Sedan Range

## TECHNICAL BULLETIN

## New Special Tool 18G 1433/A – Camshaft Timing

MODEL 1995 MY Sedan (4.0L) Range VIN

**ILLUSTRATION 1**

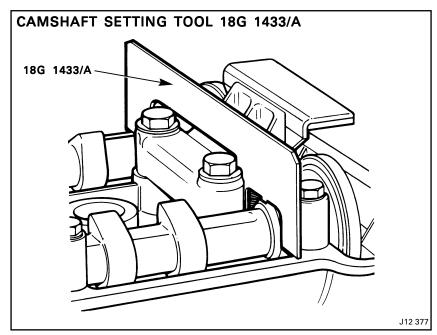
18G 1433/A is a redesigned camshaft timing tool used when setting camshaft timing. It is 3 mm thinner to accommodate the dimensions of the AJ16 cylinder head. It can also be used on AJ6 engines.
